**WATTS BAR NUCLEAR PLANT (WBN) UNIT 1 - AMERICAN SOCIETY OF
MECHANICAL ENGINEERS (ASME) SECTION XI, INSERVICE INSPECTION
(ISI) PROGRAM RELIEF REQUEST 1-ISI-07 THROUGH 1-ISI-12 - REQUEST
FOR ADDITIONAL INFORMATION (TAC NO. MB1274)**

**WATTS BAR NUCLEAR PLANT UNIT 1
INSERVICE INSPECTION PROGRAM RELIEF REQUEST 7 THROUGH 12**

REQUEST FOR ADDITIONAL INFORMATION

Photo 3
View of Pump, Pump Support and Piping

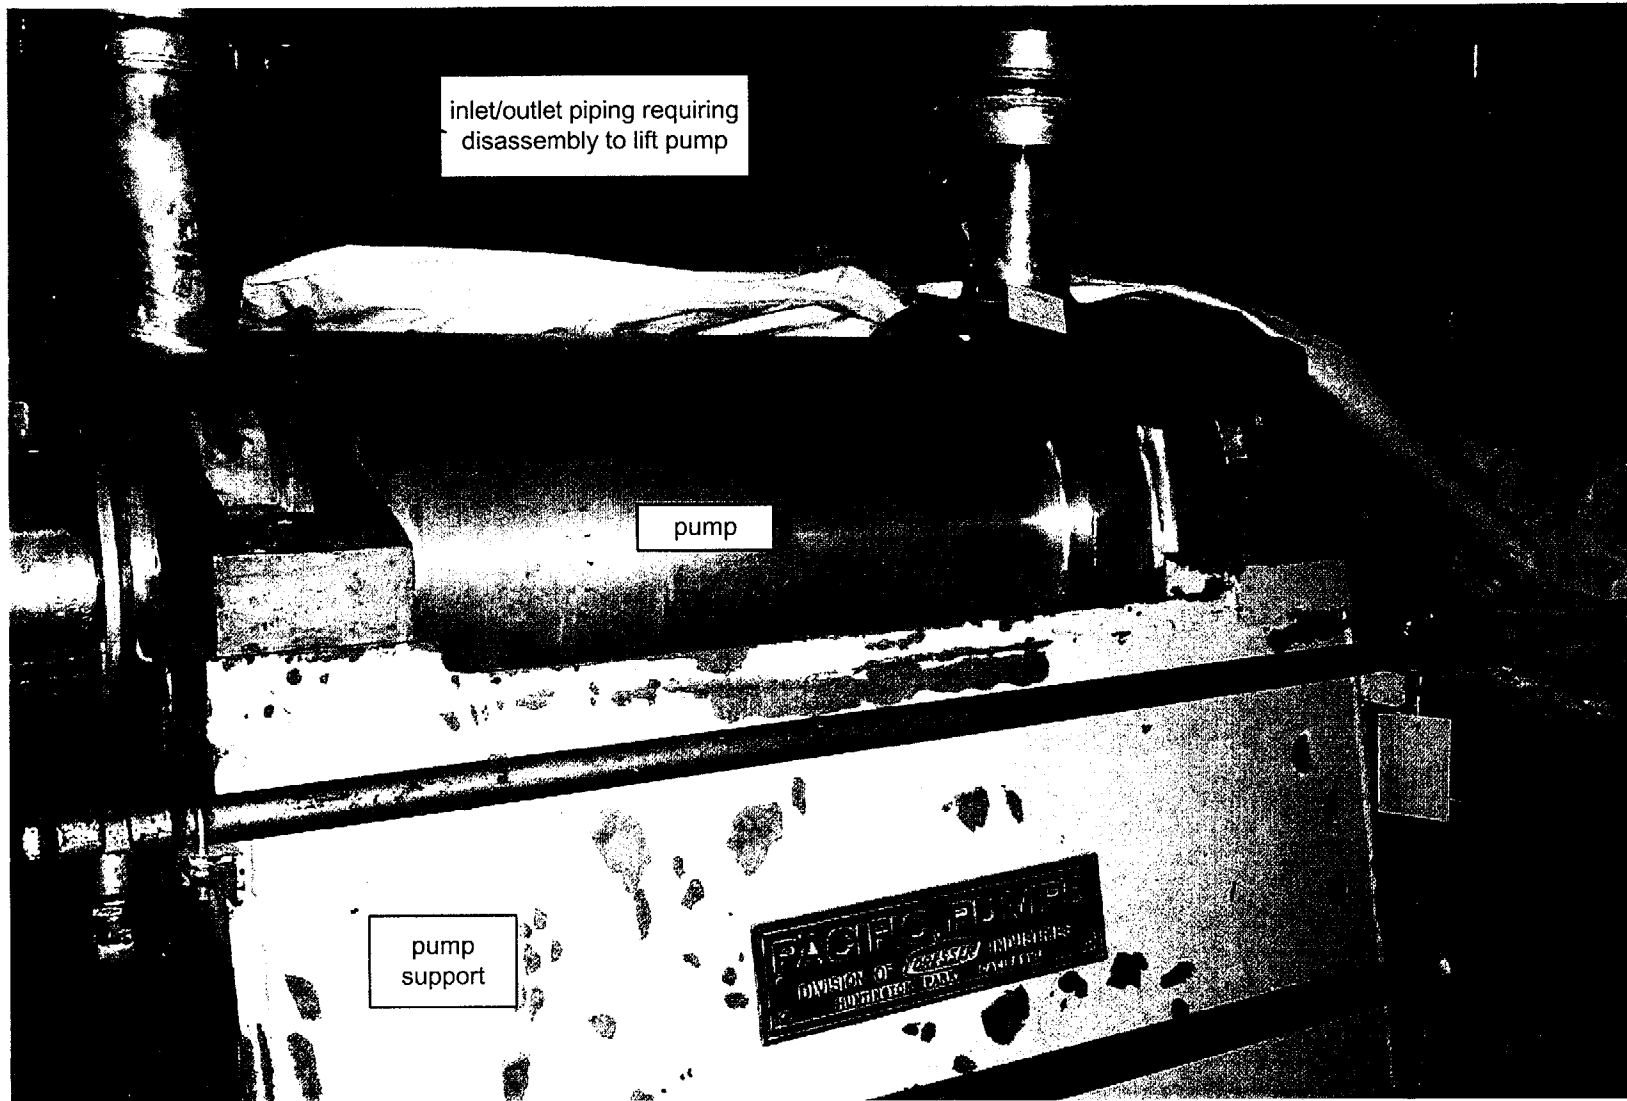
- (a) "Connecting piping would have to be disconnected and pump disassembled and lifted to allow access to the remaining 16% examination area." Clarify which piping and demonstrate with photos why the pump has to be disassembled.
- (b) "The bottom side of the attachment is inaccessible due to a support which bolts the pump to the supporting frame." Illustrate how the bolt is interfering with the PT exam.
- (c) "Other NDE techniques were considered;..." What other NDE techniques were considered.
- (d) "The maximum...and adjacent metal of the subject weld provides reasonable assurance of an acceptable level of quality and safety." Illustrate the adjacent metal of the subject weld.

- (a) The piping requiring disassembly is the inlet and outlet pump piping as shown in Photo 3 of Attachment 2. To obtain access to the inaccessible portion of the weld, this piping would be required to be disassembled, the pump uncoupled from the motor and the pump lifted off the pump support.
- (b) Refer to Photos 1, 2, and 3 in Attachment 2. It is not a bolt which interferes with the PT examination, but the configuration of the pump "bolted" to the support. As noted in the photos, the cylindrical pump housing is "cradled" on the pump support with the subject integral attachments

Photo 1
Shell-to-Flange Weld in Relation to
Nozzle and Support Pad

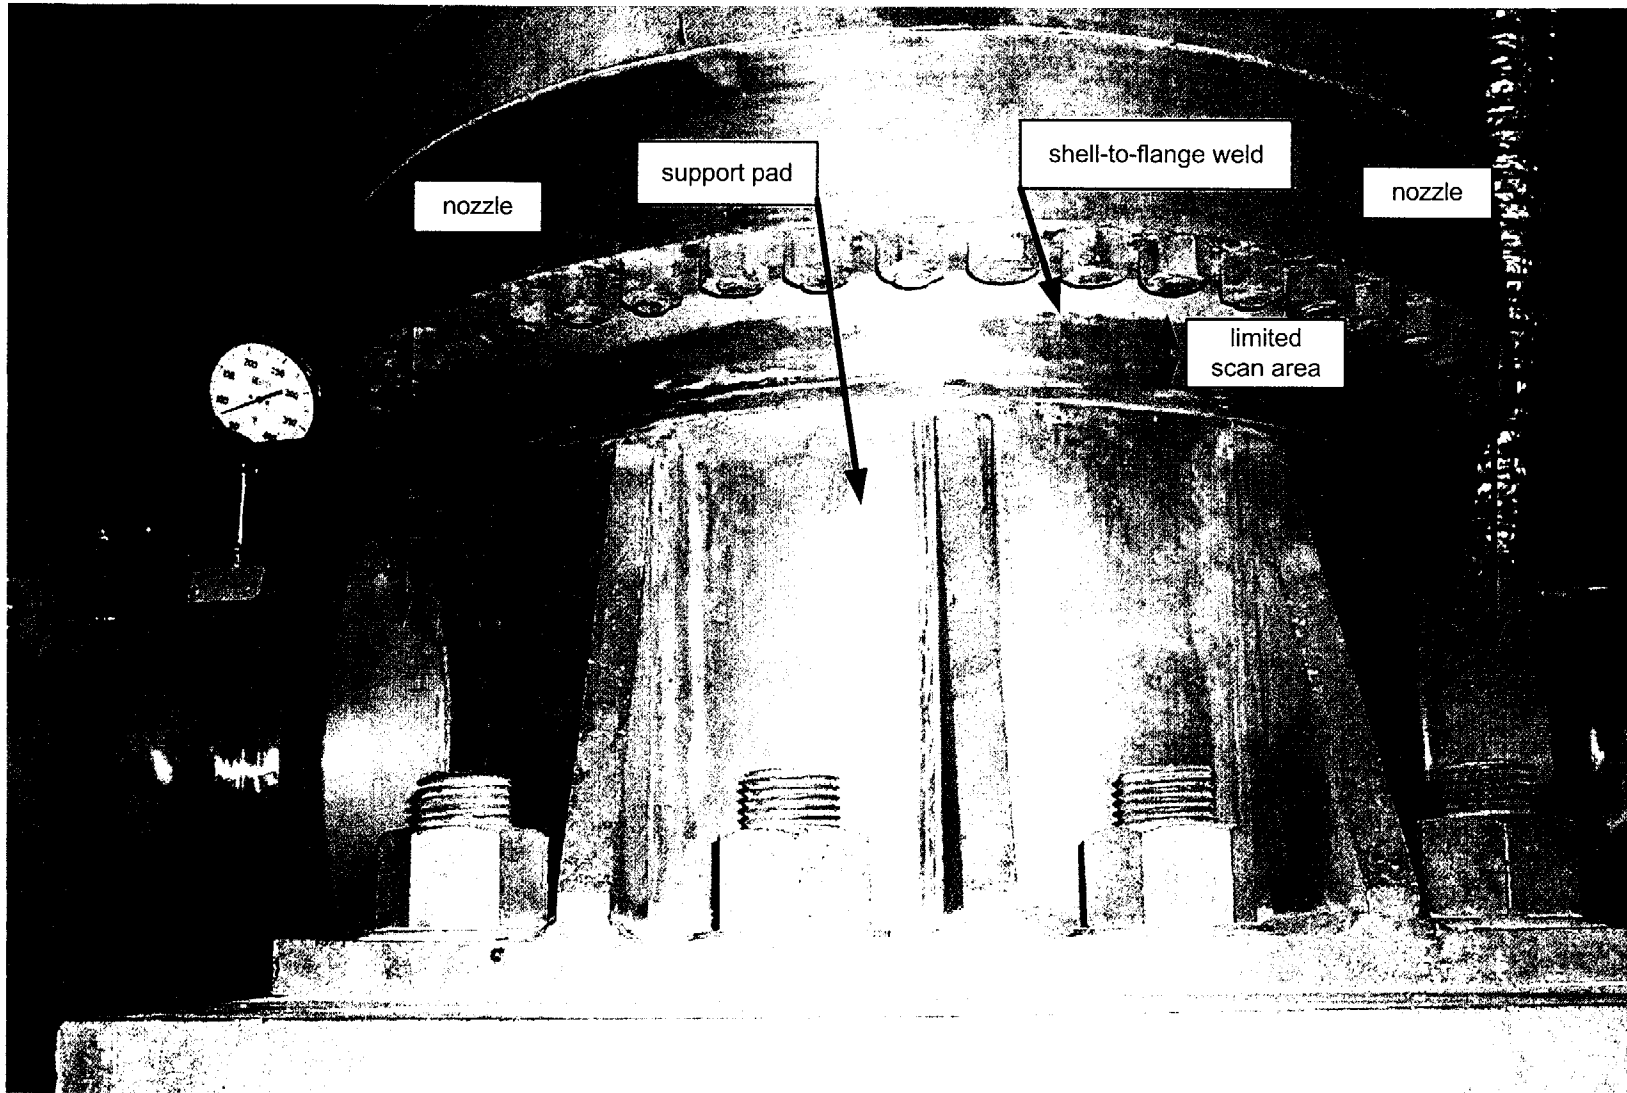
- (1) It is stated in Section VI that "As noted, the outside diameter of the nozzle is 18-1/2 inches and the width of the support pad is 18 inches. These are mounted on the 22-5/16 inches wide shell." Clarify this with sketches/photos.
- (2) Confirm that an attempt to perform a surface examination of the subject welds has been made.
- (3) Confirm that VT-2 visual examination will be performed during the pressure testing as required by Section XI.

- (1) Photos of the subject area are provided in Attachment 3. The location of the 18½-inch nozzles and 18-inch wide

support pad on the heat exchanger shell limits the scan area for the shell-to-flange weld. Note these photos are of the Unit 2 heat exchanger which has a similar configuration as the 1A heat exchanger. The Unit 2 heat exchanger is also located in a separate room with the insulation removed. Since Unit 2 does not have an operating license, there is no dose associated with the Unit 2 heat exchanger.
